From: [Henriquez, Jose](#)
To: [AC, EPD Customer Services](#)
Cc: [TCCS_PC DACOORD](#); [Wyatt, Tim](#); [Chowdhury, Abu Sayem](#); [Davies, Richard](#); [Jatheendran, Lingam](#); [Li, Xunyong](#); [Evans, Amanda](#); [Yarra, Maxwell](#); [Motha, Antony](#); [Senarath, Nethmei](#)
Subject: COMM: TCCS-202139248-13/22 KINGSTON-01
Date: 3 November 2021 15:07:19
Attachments: [image001.jpg](#)
[image002.png](#)
[2021.10.26 VS19068 Giles Street C.101\[2\].pdf](#)
[2021.10.26 VS19068 Giles Street C.100\[2\].pdf](#)
[SUPP-202139248-TCCS CORRESPONDANCE-01.obr](#)
[FW VS19068 - Giles Street - B13 22 S22 Kingston - Proposed Shared Service Easement.msg](#)

DEVELOPMENT APPLICATION NO: 202139248

PROPOSAL FOR A NEW COMMERCIAL DEVELOPMENT - Demolition of the existing buildings, pavements and structures and construction of a new four-storey commercial building with two level basement carparking, 5 surface carparking spaces, landscaping, removal of one verge crossing from Giles Street and modified vehicle access to the Laneway to the south of Block 22 and associated works.

BLOCK: 13	SECTION: 22	SUBURB: KINGSTON
------------------	--------------------	-------------------------

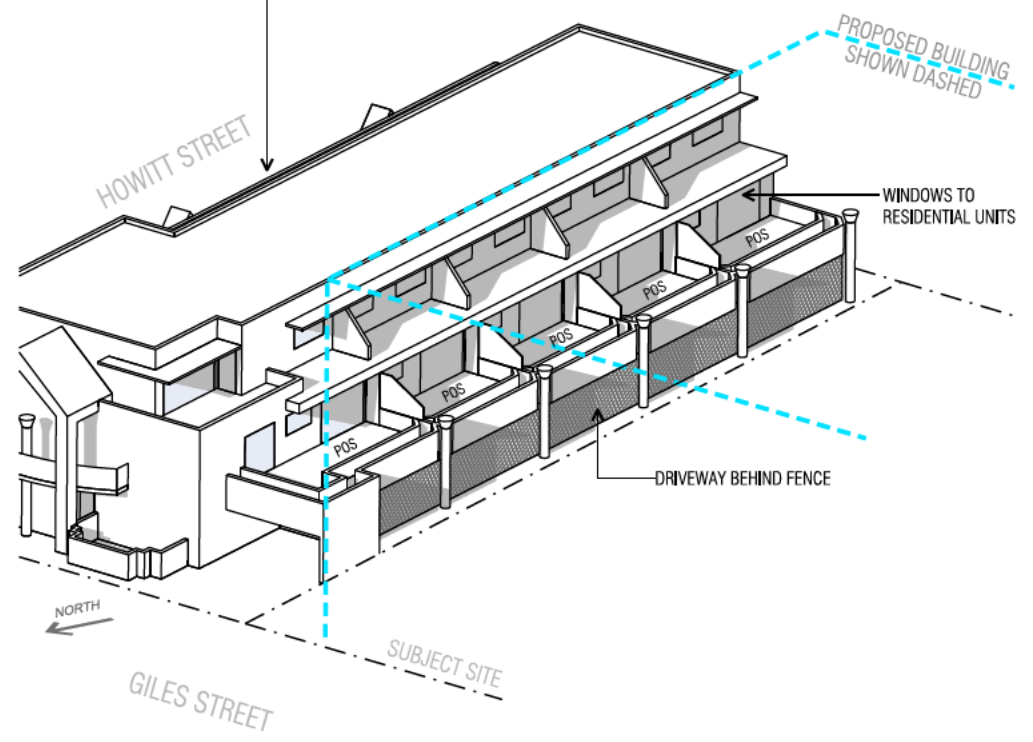
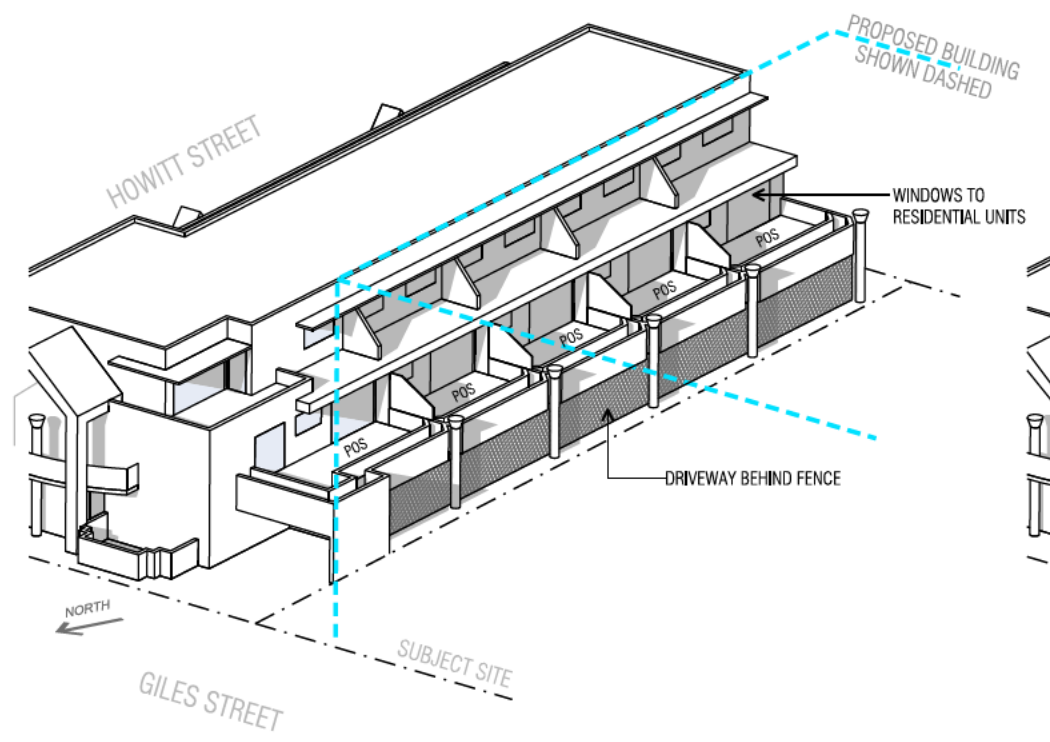
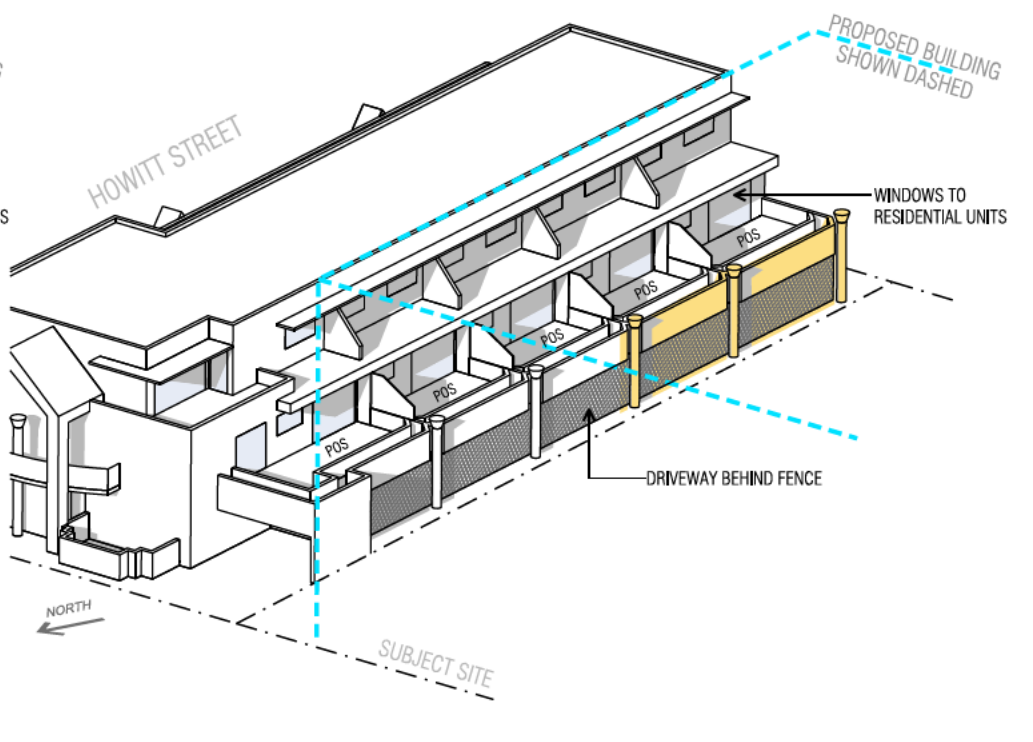
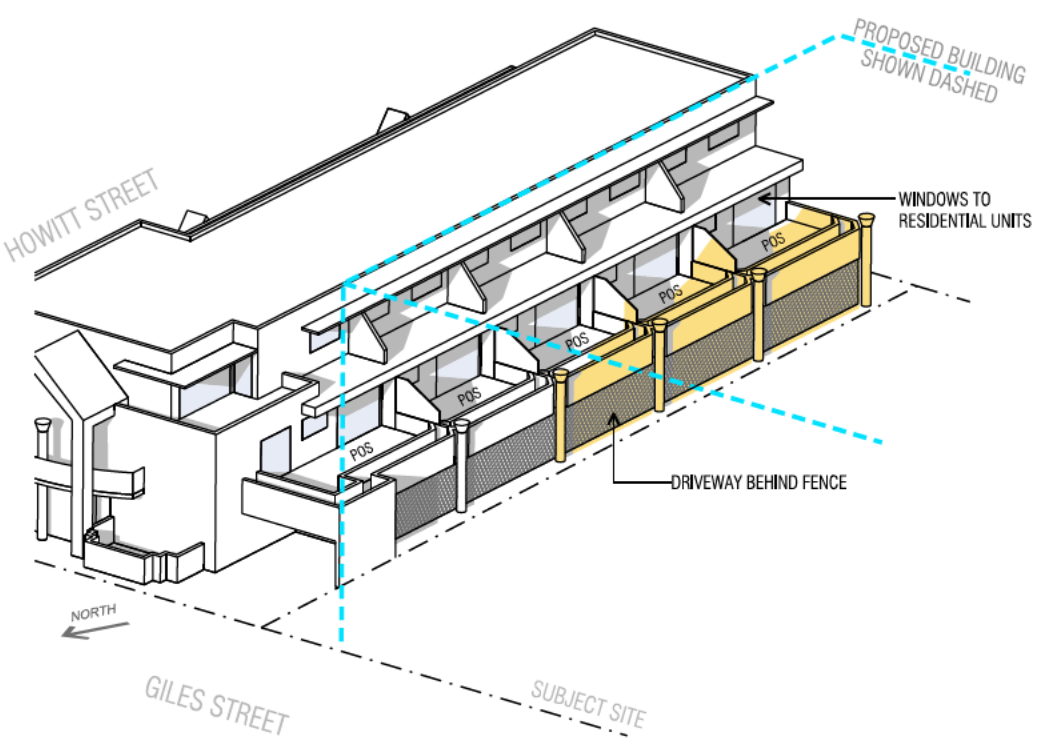
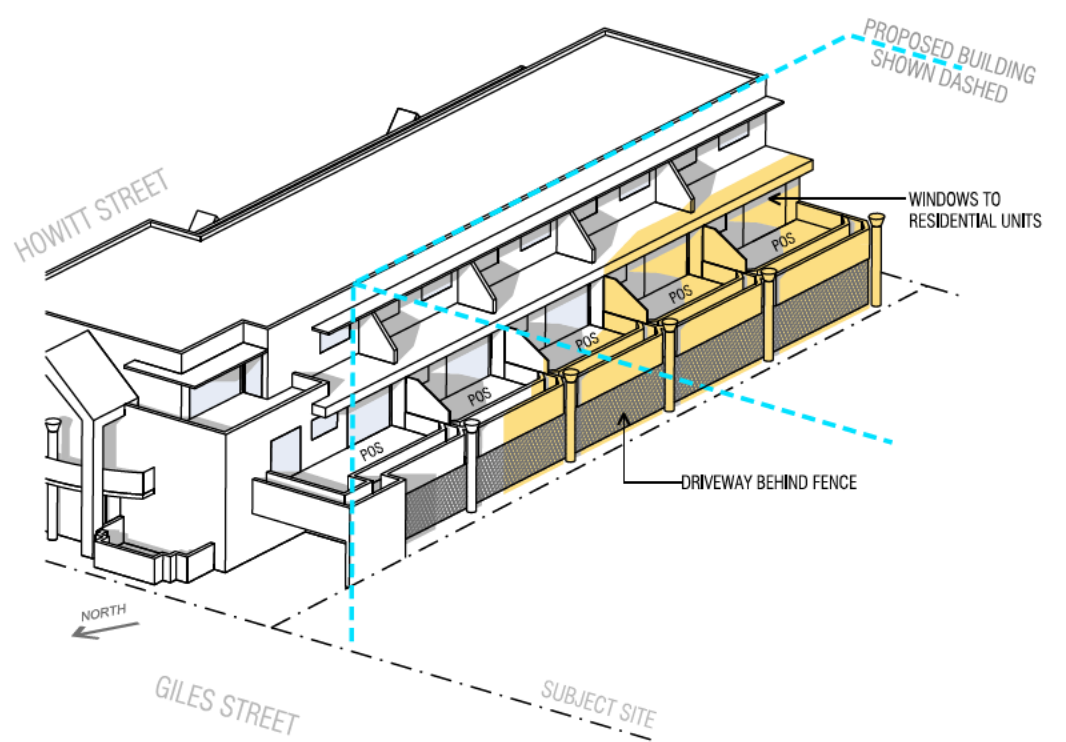
In the Shadow Studies, Block 14 Section 22 Kingston documentation, the Holford residences are noted as having a "DRIVEWAY BEHIND SOLID WALL" when the reality is a DRIVEWAY BEHIND A WIRE FENCE. The differences between a solid wall and a wire fence are obvious and can be seen within a 1-minute site visit: natural light entering the driveway of the Holford, light allowing the growth of plants along the wire fence, breezeway through the space. The impact of increased noise from the excessive commercial building is discounted.

The Shadow Diagram (Document 61) for the development show a solid wall on the boundary next to Block 14 adjoining the garage area of the Holford. The wall will effectively remove or kill the current greenery and replace an area of filtered daylight with an unacceptable dark tunnel.

Some representations stated the shadows as displayed did not provide enough detail or were presented in a way to diminish the overshadowing extent. This included:

It is noted that the solid wall does not exist and changes to the affected plan have been made for clarity. However, no deliberate misrepresentation of off-site dwellings has been made within the drawings provided. No mention of the Holford dwellings PPOS facing Howitt Street has been made in the drawings or Planning report provided in the submission. The additional drawing *DA401 Shadow Studies (Holford)*, was made in response to the pre-DA consultation that was undertaken by the proponent team. Another in-depth shadow studies diagram has been provided with this response which shows a similar level of detail to DA401 for Block 19 to the southeast of the site.

- That dwellings on Block 19 are provided with Private Open Space facing Howitt Street accessible via habitable rooms (to which this development does not provide additional overshadowing).
- That the design and orientation of the adjacent dwellings on Block 14 mean the privacy walls between the PPOS balconies already provides shadowing of the spaces.
- That the shadow effects of the proposed development begin to shadow the PPOS of dwellings on Block 14 from 2:45pm.

With the updated shadow diagrams provided with this response, it is considered the project team have adequately and accurately displayed the shadow effects that will result as a consequence of this development.
